Product / Process Change Notification (PCN)

PCN #: PCN_PD_20220610
Affected Series: WE-PD; 7447789xxx
 WE-PD; 7447779xxx

PCN Date: March 10, 2022
Effective Date: June 10, 2022

Part number 7447789004

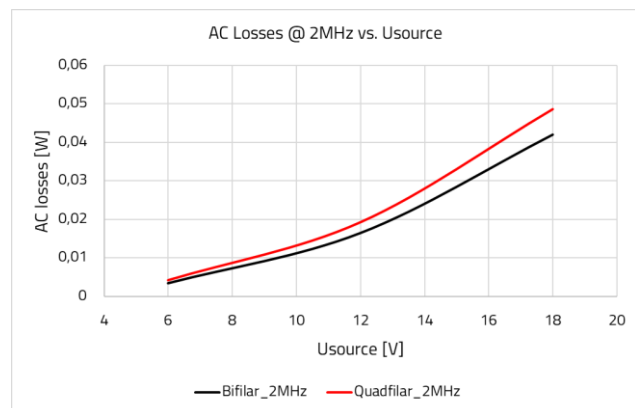
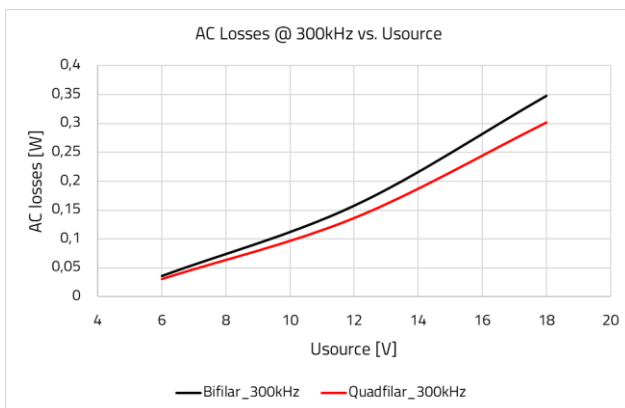
The change will also affect the AC loss behavior of the articles. The impact is dependent on the end application in which the product is used.

Below 2 Graphics are a reference of how the AC loss can be affected by different operating frequency.
